TEKTRONIX INTERNAL USE ONLY

Published by Service Admin Support

September 25, 1981  
Issue 11-18

Figure 1. Addition of C25 and R25 to dynamic focus circuitry.

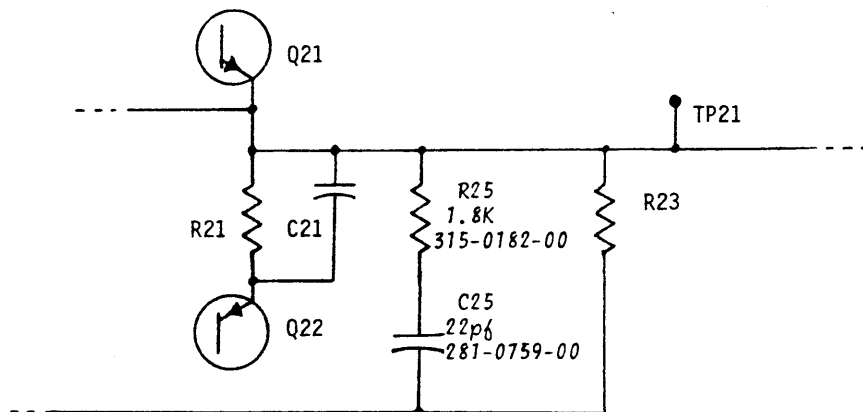
Focus uniformity has been adversely affected by an offset in the dynamic focus waveform. To correct this, a series RC circuit (R25 and C25) is added in parallel to R23. This is depicted in the schematic of figure 1. The addition of these two components changes the standard interface board from 670-5592-03 to -04 and the option 14 board from 670-5965-01 to -02.

Figure 2. Component layout on back of high voltage board.

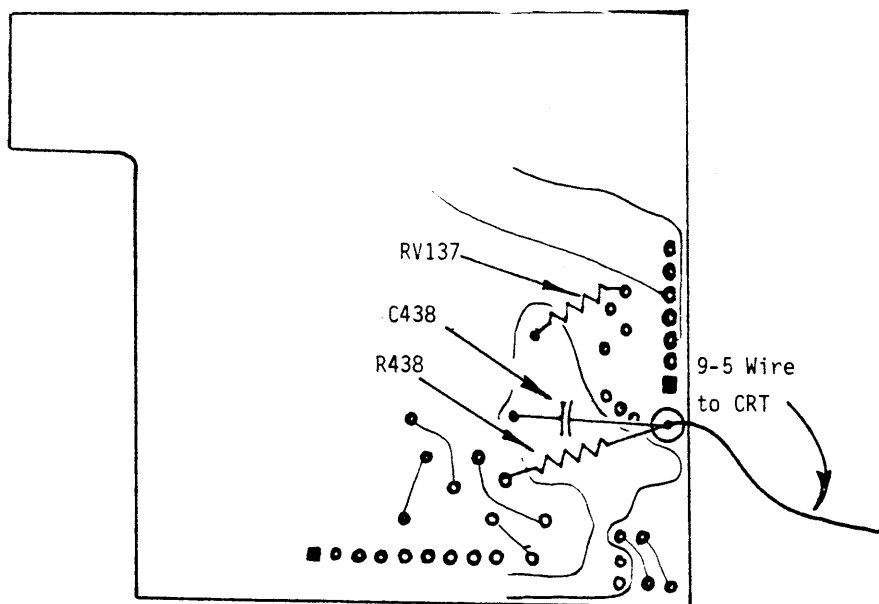
Visible noise in the raster has been caused by ripple in the +62 Volt supply. To reduce this ripple (and the noise), C438 and R438 are added to the back side of the high voltage boards. This is not a straight forward "Tee-Pee" and must be done in the following manner.

- Relocate RV137 to the position shown in figures 2 and 3. The functioning and schematic representation of RV137 does not change.
- Install a terminal post (131-0157-00) in the tooling hole near the number 1 lead of T410 (high voltage transformer).
- Add C438 from ground to the terminal. Protect the lead to the terminal with 1/2" of 162-0042-00 sleeving.
- Solder in R438 between the pad shown in figure 2 (junction of C437 and wiper of R435) and the terminal. Cover the whole resistor with a 1" length of 162-0042-00 sleeving to prevent it from shorting to nearby components or the underlying ground run.
- Solder the 9-5 (white background, green stripe) CRT lead to the terminal.

The addition of these components changes the standard high voltage board from 670-5593-02 to 670-5593-03, and the option 15 high voltage board from 670-6403-01 to 670-6403-02.

### 7104, 7854 LOW LINE, HIGH LOAD, POWER SUPPLY SHUTDOWN

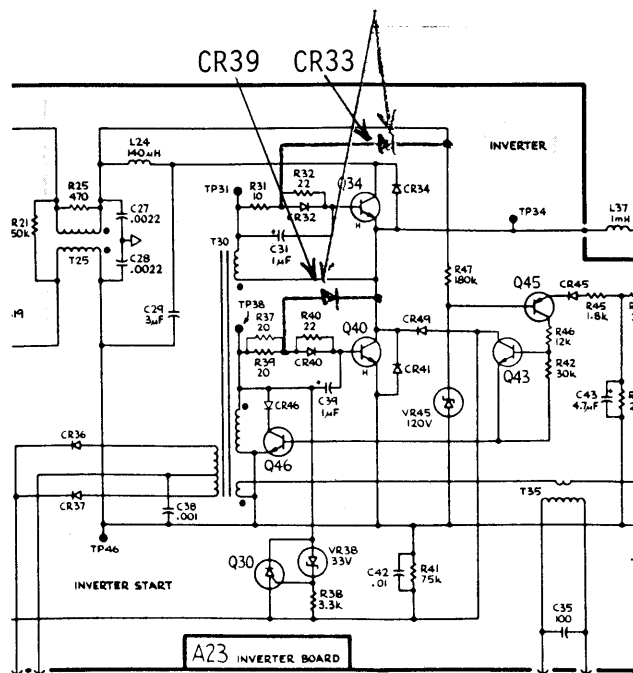
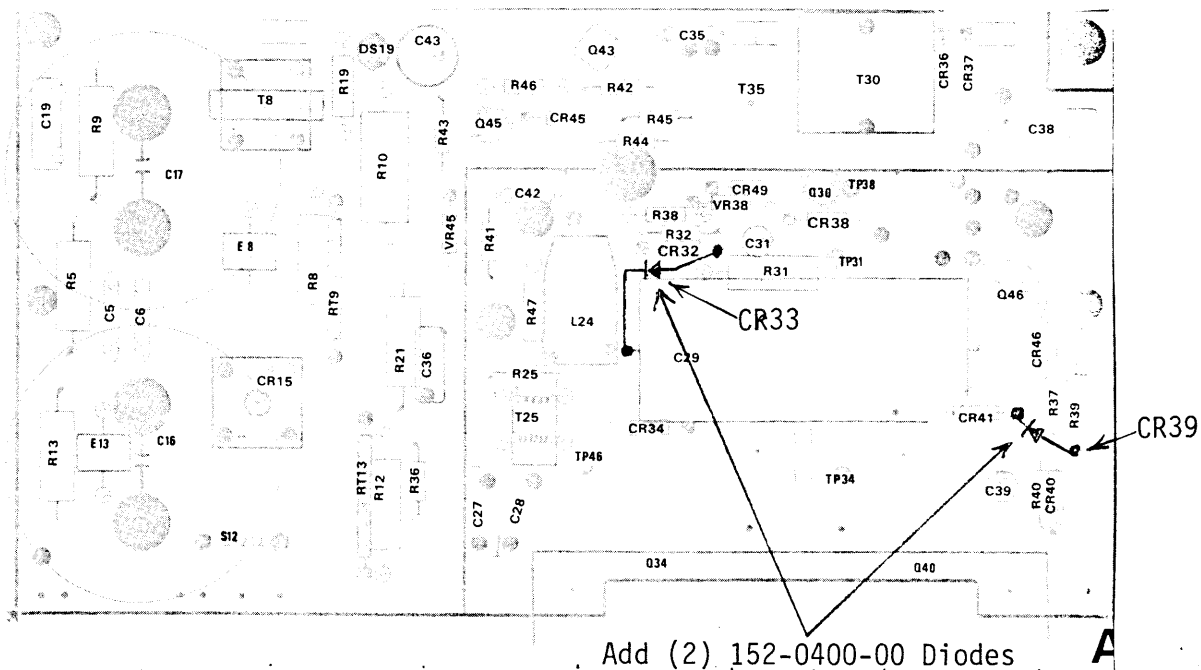
The problem was originally solved by corporate mod #42248, by selecting the inverter transistors and part numbering them 151-0632-03. The vendor is having problems supplying this part, so this part will be deleted and the following mod added.

The following description and drawings will use the 7854 part numbers, so refer to the manual for the corresponding 7104 part numbers. Add CR33, P/N 152-0400-00, from the collector of Q34 to junction of R31 and R32. Add CR39, 152-0400-00, from collector of Q40 to the junction of R39 and R40.

## CONTROLLER BOARD PARTS DIAGRAM

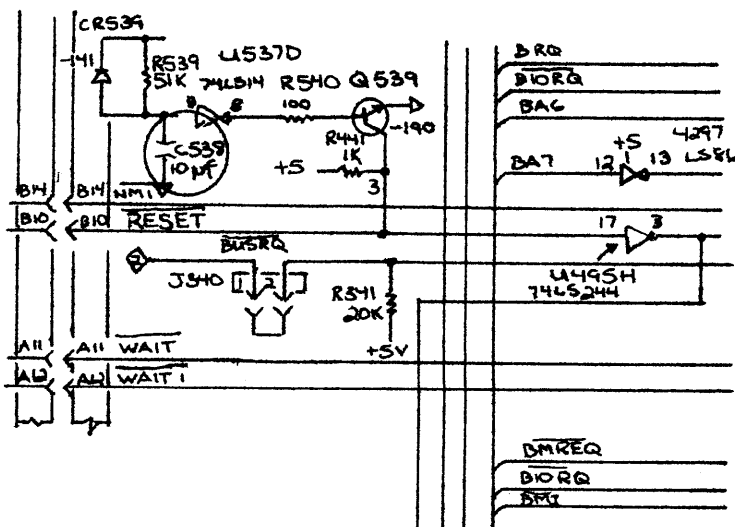
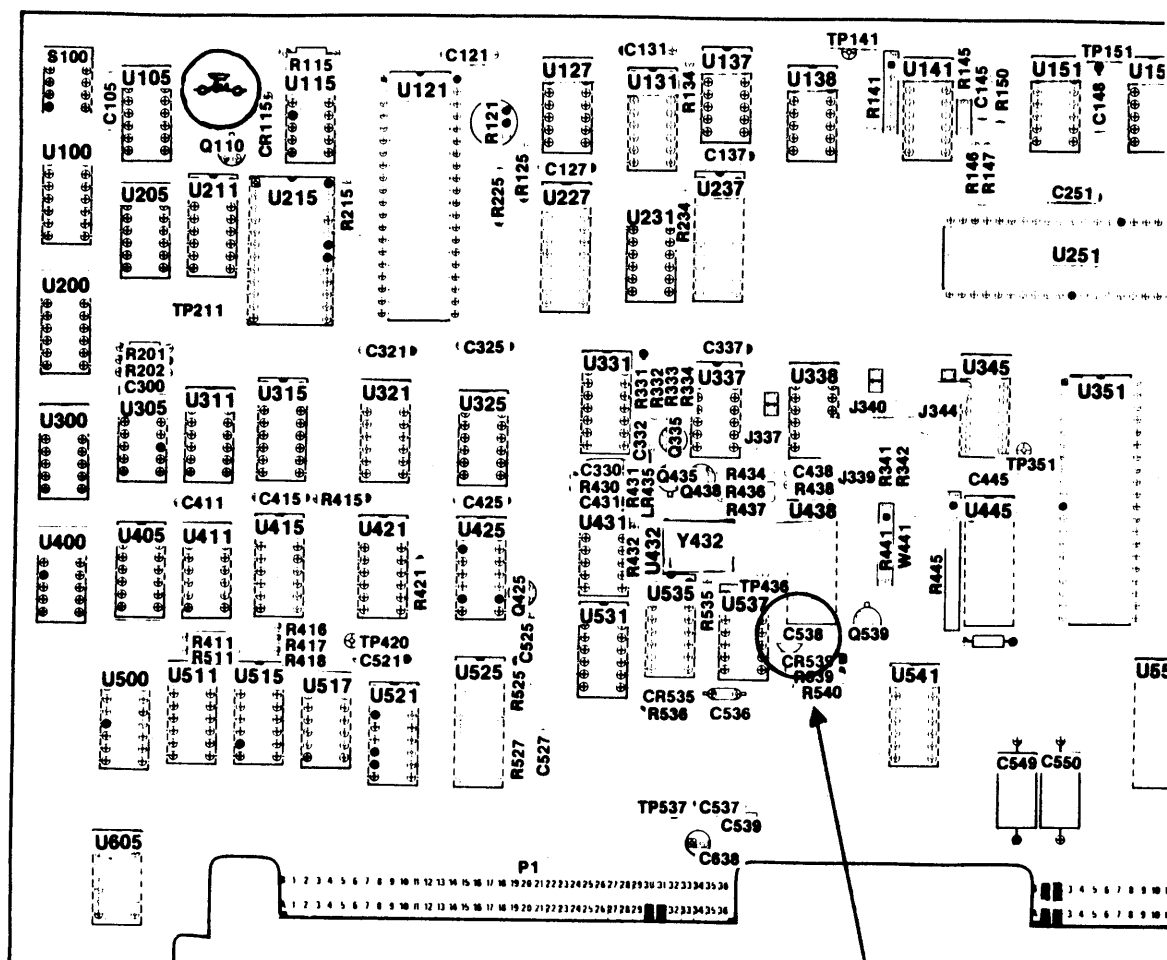
To cure this problem, C538 on the controller board was changed from a 10 $\mu$ f, electrolytic capacitor (Part Number 290-0536-00) to a 100 $\mu$ f, electrolytic capacitor (Part Number 290-0755-00).

See the attached diagrams for schematic changes and circuit location.

Fig. 1

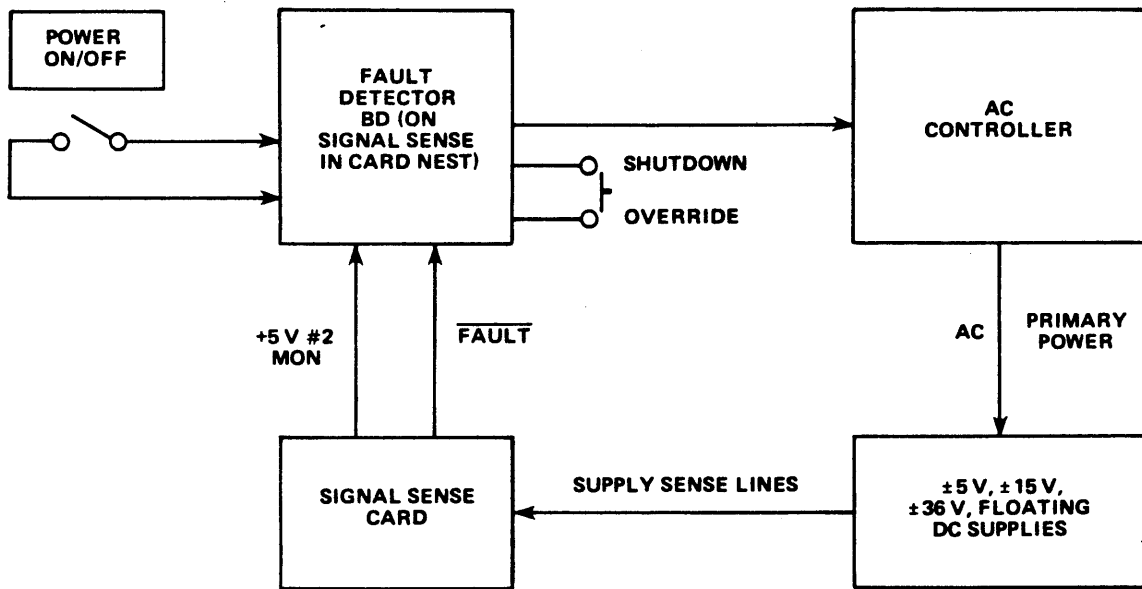
The nine-second timeout of U410A provides enough time-out delay to override the FAULT/ and +5V MON lines when the test station is first powered up, as faults will be present until the power up-sequence is completed. Upon completion of the timeout, the reset line of the r/s combination of U420A and U420B monitors the FAULT/ and +5V MON lines by way of Q110, Q120, U210, and U420C. Q110, Q120, and associated circuitry provide filtering to the FAULT/ or +5V MON lines to prevent transients from inadvertently generating a fault condition. When a fault condition is indicated by the FAULT/ or +5V MON lines, U420A and U420B will reset, forcing Q001 and Q010 off, thereby turning off the associated ac controller to shut down the test station. LED DS400 indicates that a fault has occurred.

Fault Detector circuit board component layout.

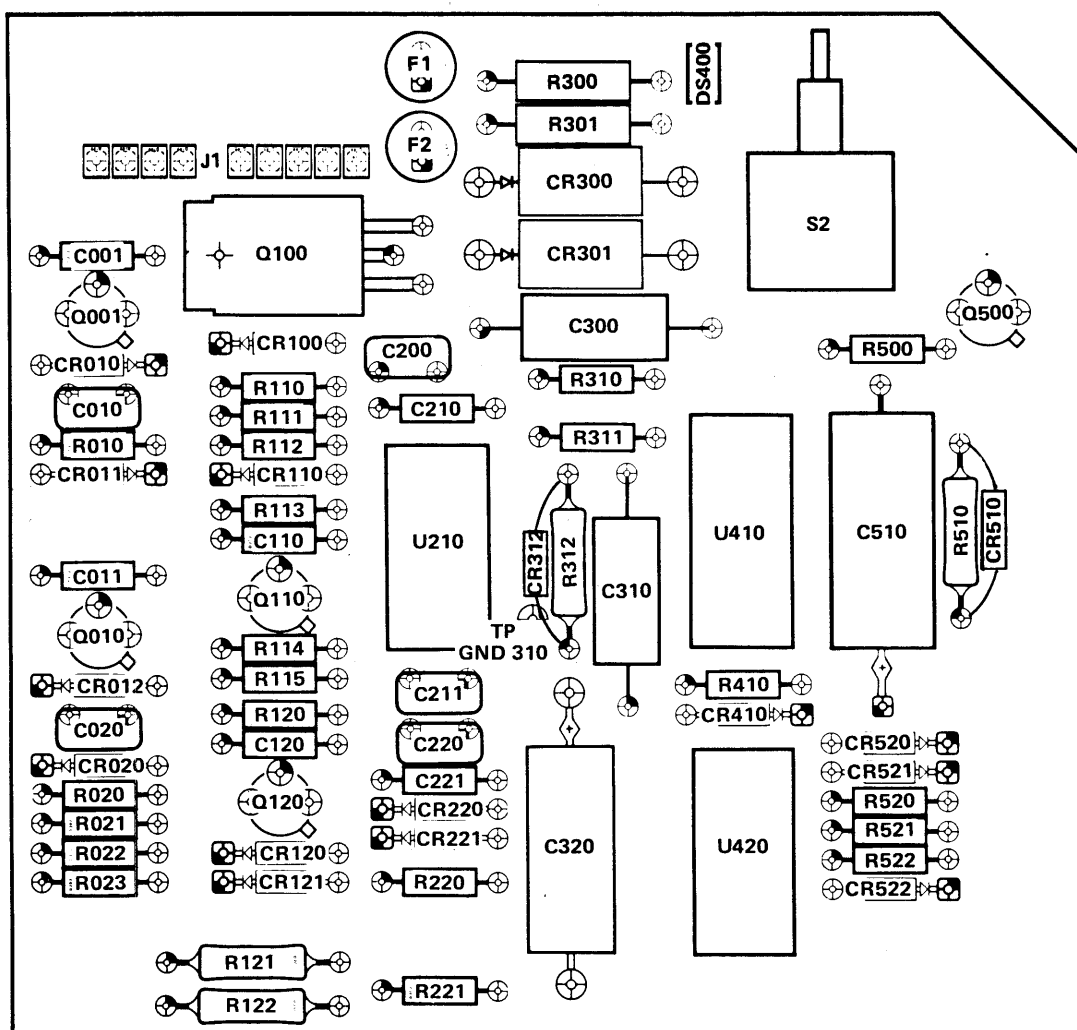
The addition of the Fault Detector Circuit Board 670-7545-00 to the Signal Sense Card 670-3782-01 creates a new Signal Sense Assembly 672-1043-00. The assembly created by adding the Fault Detector Board to the Signal Sense Card 670-3782-00 has not been part numbered. However, it will function the same as the 672-1043-00 Signal Sense Assembly. In either case the correct replacement assembly is the 672-1043-00 Signal Sense Assembly.

The addition of the Fault Detector Board to a 670-3782-01 Signal Sense Board will change the 670-3782-01 to a 670-3782-02. A label with the new assembly part number is provided in each update kit. This label, 672-1043-00, should only be placed on assemblies created from the 670-3782-01 Signal Sense Circuit Board.
